Access Compliance Report

Public Rights-of-Way

Intersection ID: 48138	Main Street: BEATY_CALDWELL_LN	Cross Street: MCCAMEY_DR	Location: SW
ADA ID: AE8E5780A581	Ramp Type: PerpDiag	Initial Pass/Fail: Fail	Overall Compliance: No
Severity Score: 8.75			
Codes/Mitigation Info/Possible Solution		Field Measurements/Component Compliance

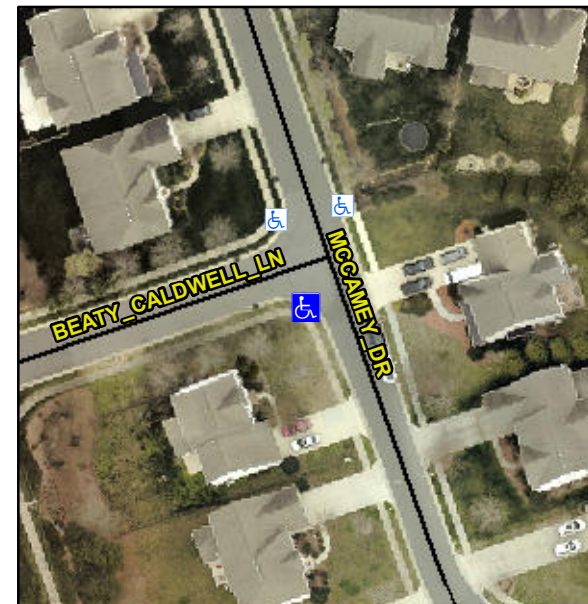
Not Found, R304.5.1

Compliance	Description	Data	Compliance	Description	Data
N/A	Ramp Length (in)	48.0	Yes	Ramp Slope (%)	7.6
No	Ramp Width (in)	47.0	Yes	Ramp XSlope (%)	2.0
N/A	Flare Type LT	N/A	N/A	Flare Type RT	N/A
N/A	Flare Slope LT (%)	N/A	N/A	Flare Slope RT (%)	N/A
N/A	Flare Traversable LT?	N/A	N/A	Flare Traversable RT?	N/A
N/A	Landing Length (in)	N/A	N/A	DWS Provided?	N/A
N/A	Landing Width (in)	N/A	N/A	DWS Contrast?	N/A
N/A	Landing Slope (%)	N/A	N/A	DWS Length (in)	N/A
N/A	Landing X Slope (%)	N/A	N/A	DWS Full Width?	N/A
N/A	Landing Curb? (Y/N)	N/A	N/A	DWS Offset (in)	N/A
N/A	Shared Landing?	N/A			
N/A	Gutter Ponding?	N/A	N/A	Gutter Slope (%)	N/A
N/A	Gutter Lip Ht (in)	N/A	N/A	Gutter X Slope (%)	N/A
N/A	Painted X Walk1?	No	N/A	Painted X Walk2?	No
	X Walk 1 Direction	To E		X Walk 2 Direction	To N
N/A	X Walk 1 Width (in)	N/A	N/A	X Walk 2 Width (in)	N/A
	X Walk 1 Slope (%)	1.7		X Walk 2 Slope (%)	2.2
	X Walk 1 X Slope (%)	1.4		X Walk 2 X Slope (%)	1.5

Remove & Replace Curb Ramp With Two New Directional Ramps or Equivalent.
